7105 OLD MERIDIAN RD.
FALCON, CO
LES SCHWAB TIRE CENTER

SITE DEVELOPMENT PLANS

LANDSCAPE PLAN

L101

1 LANDSCAPE PLAN
L101

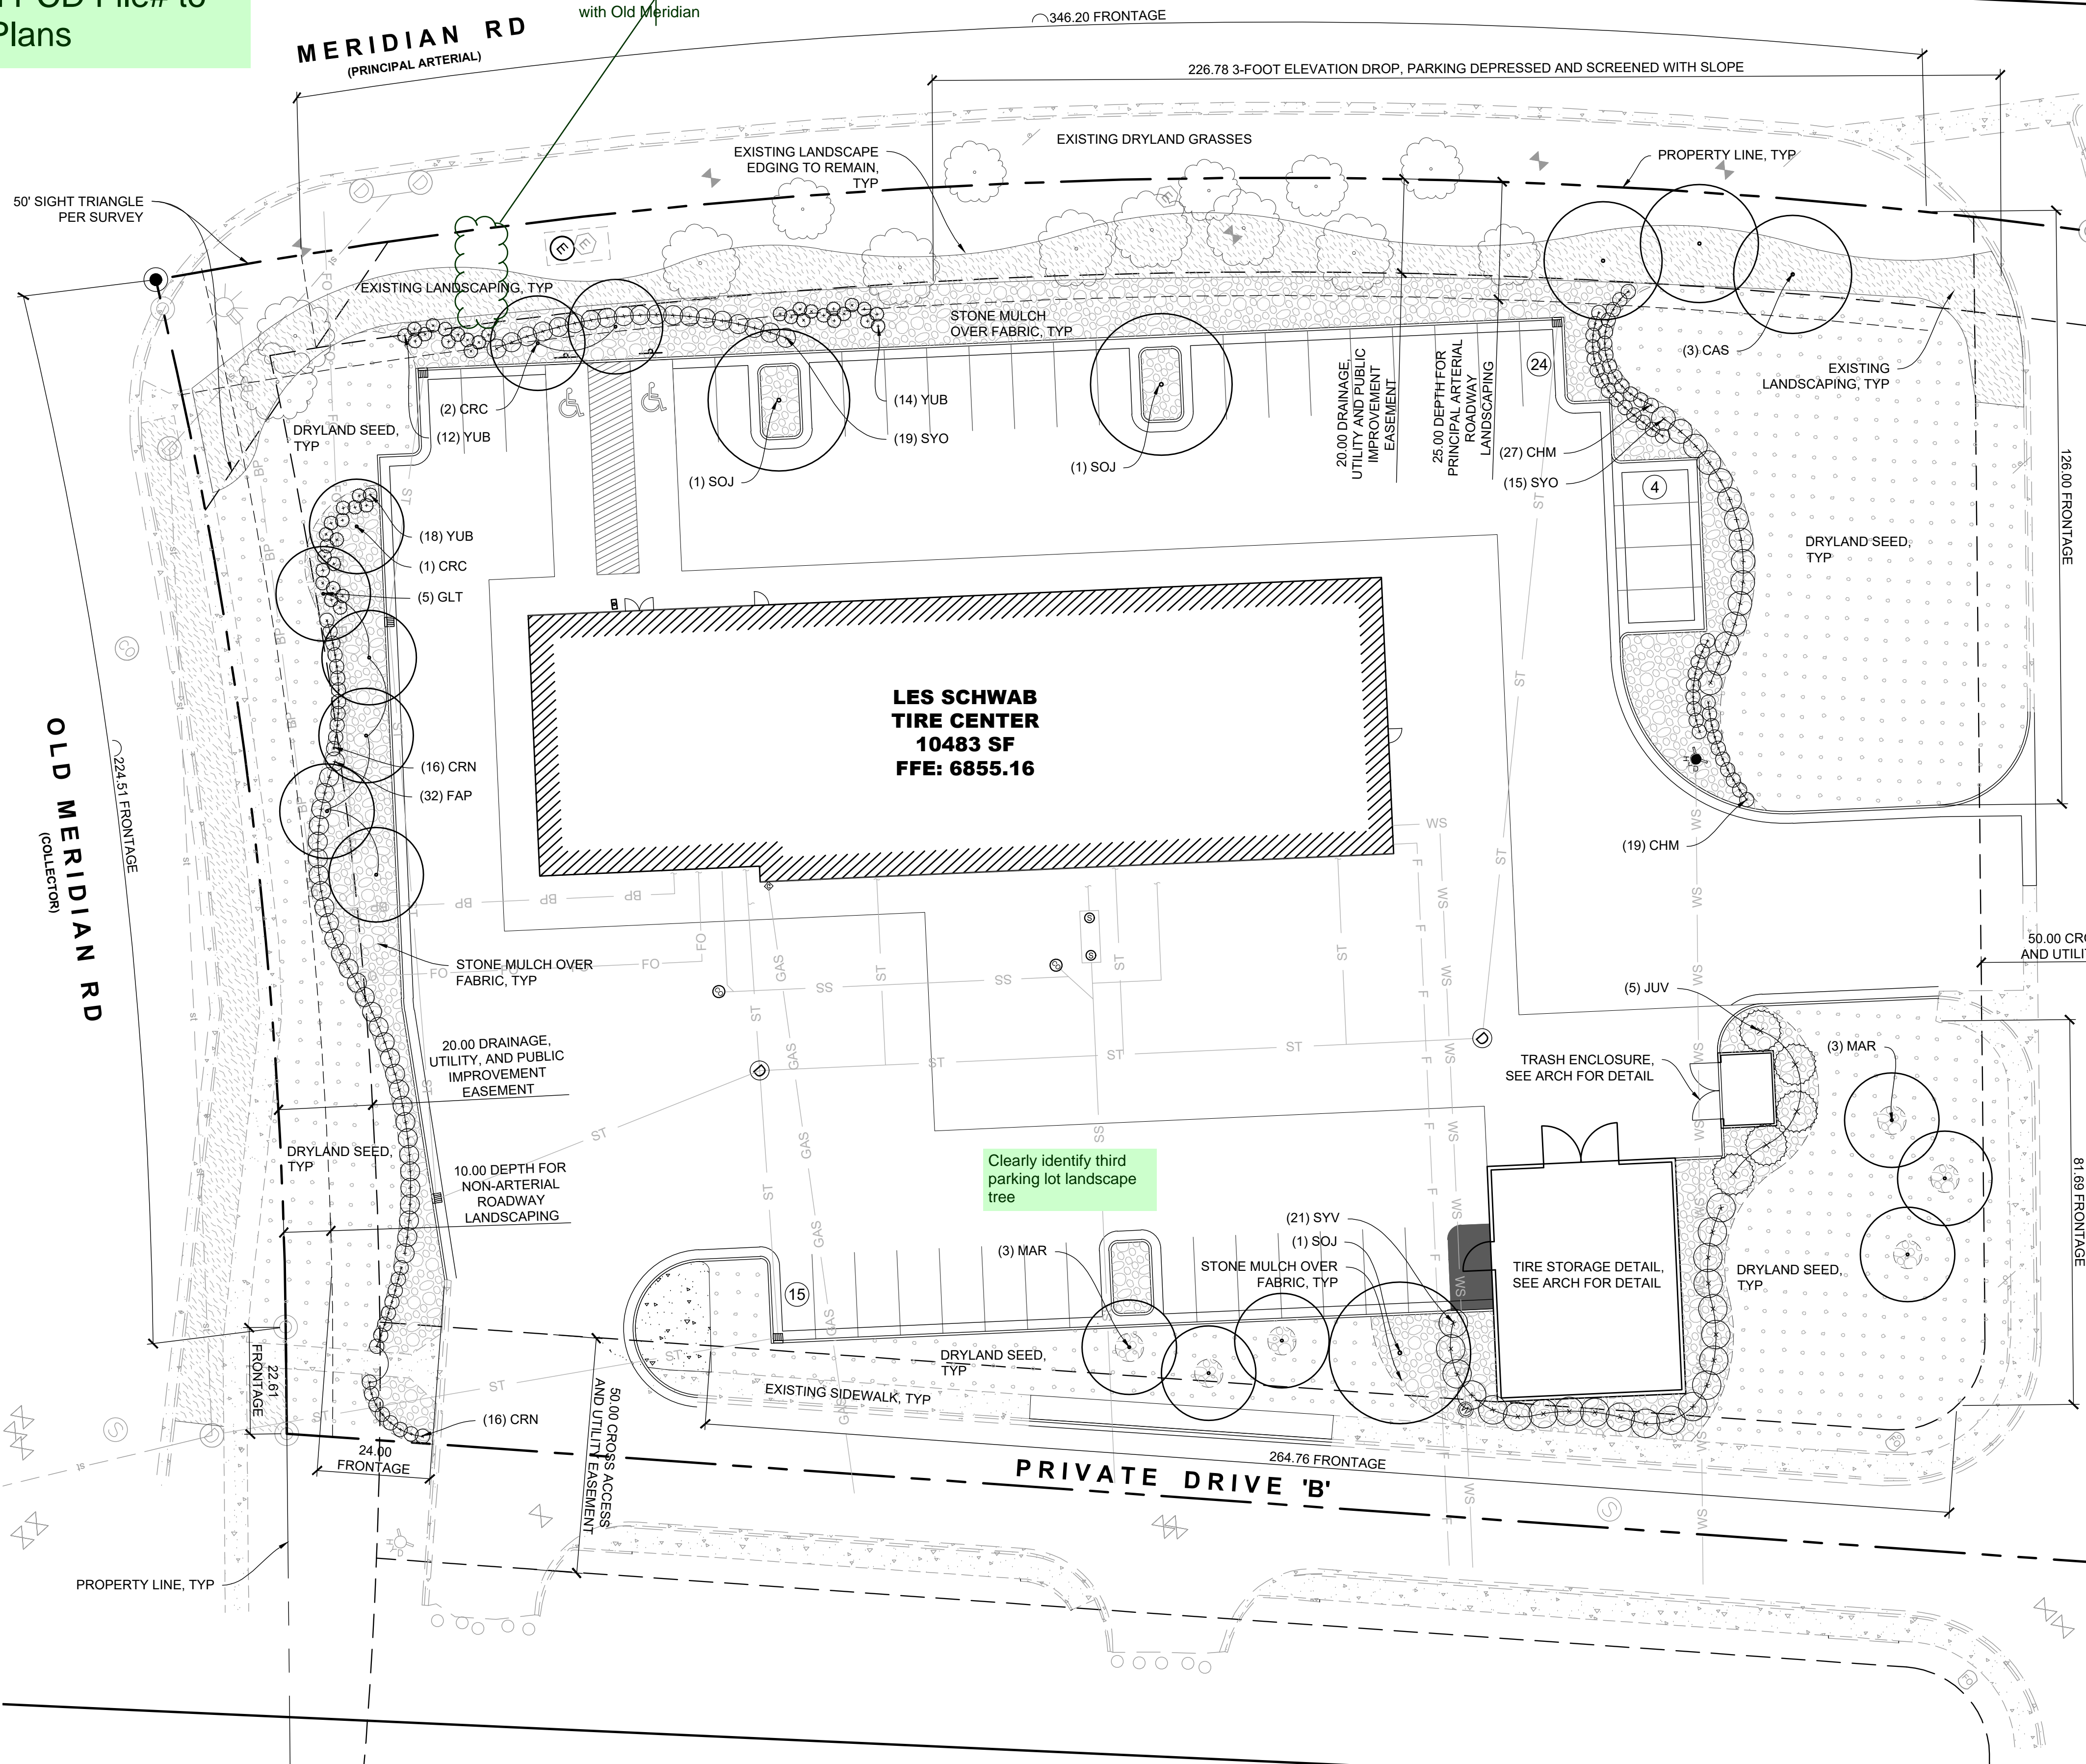
Add PCD File# to all Plans

Include required landscape depth, similar to that shown with Old Meridian

Clearly identify third parking lot landscape tree
